WOODLAND MASTER PLAN

ADDRESS : 2213 SW Heartland Court, Lees Summit, MO

LOT : HF 215

Change/Revision Log:

⑥ Main Level Base Floor Plan
1/4" = 1'-0"

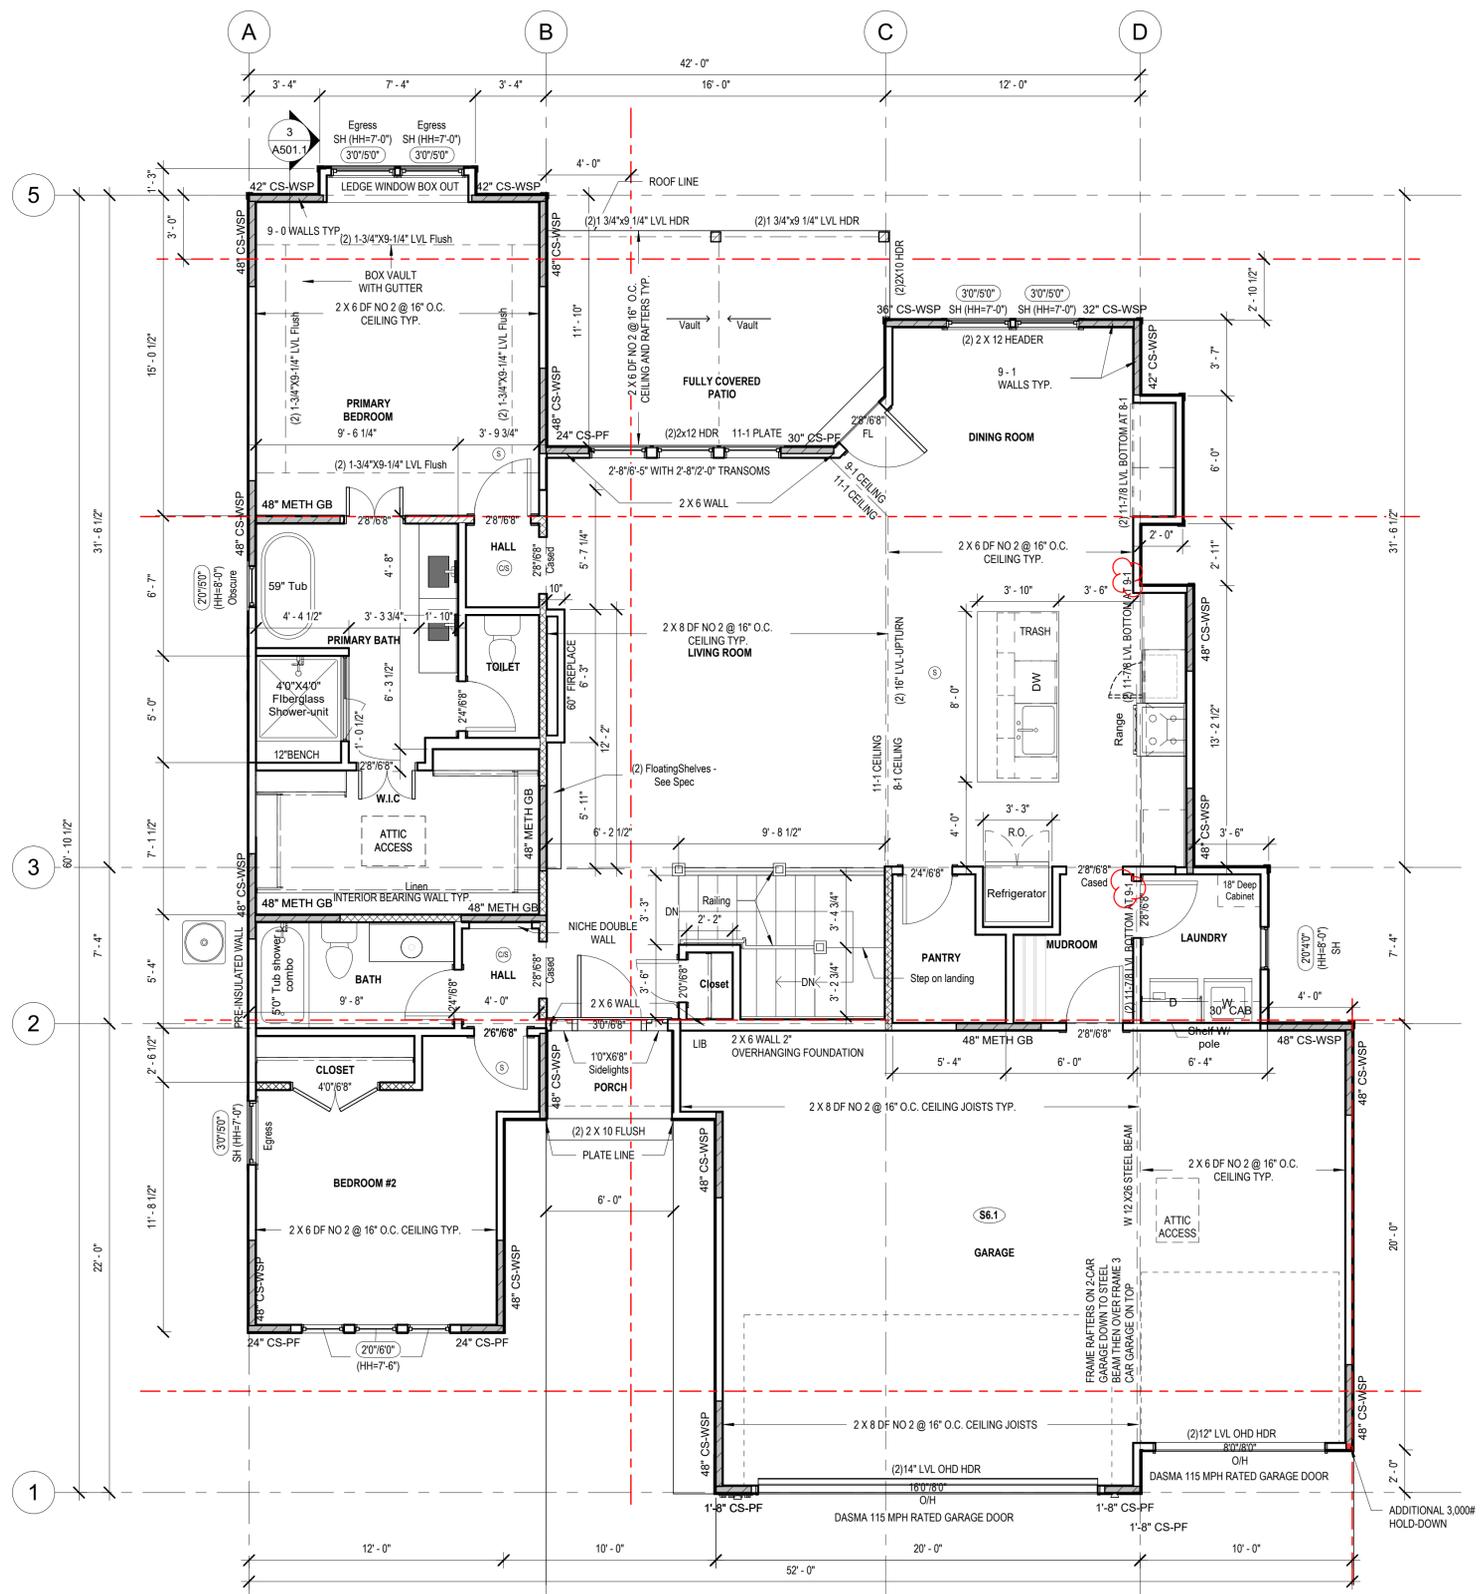
- Updated the kitchen header to be at 9-1 instead of 8-1, thus removing the soffit over kitchen nook.
- This header need to be upset and the rafters hanger into it. The over frame roof will go over this header.
- The second vanity in basement hall bath is replaced with a linen closet.
